FAILURE ANALYSIS AND PRELIMINARY CORRECTIVE ACTION WORK PLAN

**AVERY LANDING SITE
AVERY, IDAHO**

Subject: Avery Landing Site

**RE: RESPONSE TO DEQ COMMENTS ON DRAFT WORK PLAN
AVERY LANDING SITE AVERY, IDAHO**

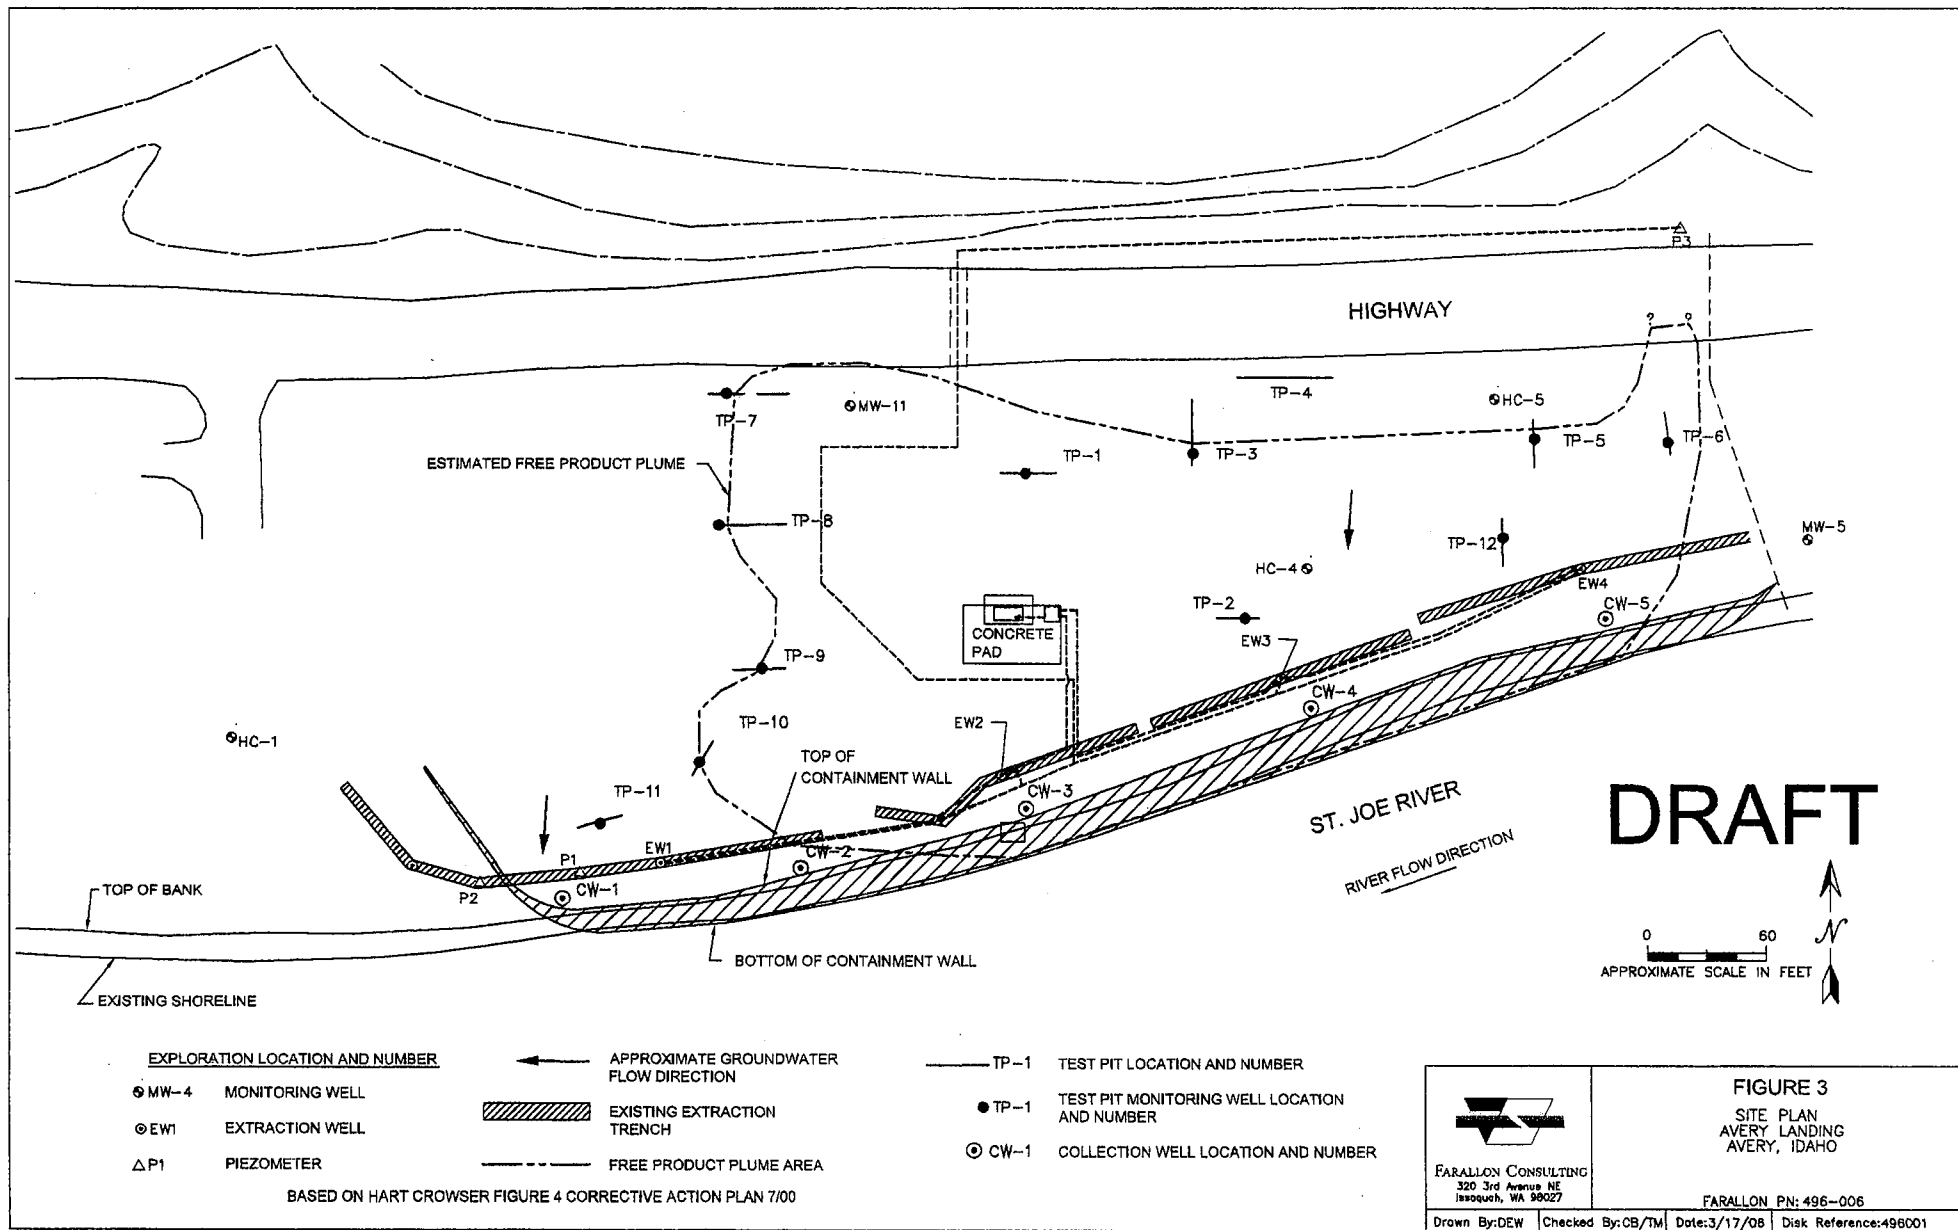
DEQ Comment 1: The natural ground water flow at the Avery Landing site would most likely be expected to flow north to south toward the St. Joe River. Placement of an impermeable wall adjacent to and along the river's length would most likely cause ground water to flow either around and/or underneath. Verifying this change in flow conditions would be helpful in determining possible discharge pathways to the river. How many wells will be surveyed and used to obtain water level measurements? Where are these wells located?

Response: *There are 27 existing monitoring wells and extraction wells that will be surveyed to the North American Datum (NAD) 1983 for horizontal and NAD 1988 for vertical. The depth to groundwater and LNAPL thickness will be measured and used to calculate the groundwater flow direction and gradient on the Site. The monitoring wells that will be monitored include MW-4, MW-5, MW-11, HC-1, HC-4, and HC-5.*

The test pit monitoring wells include TP-2, TP-3, TP-5, TP-6, TP-7, TP-8, TP-9, TP-10, TP-11 and TP-12. The extraction wells include CW-1, CW-2, CW-3, CW-4, CW-5, EW-1, EW-2, EW-3, and EW-4. The monitoring/extraction wells are all located on the Site, as depicted on Figure 3 of the Work Plan. The groundwater elevations will be measured in each of the wells to determine the groundwater flow direction and gradient on the Site. The results of the groundwater flow direction and gradient will be used to determine whether the impermeable liner changed the flow direction of the groundwater or created an under flow weir to trap the light nonaqueous-phase liquid (LNAPL) up gradient from the St. Joe River.
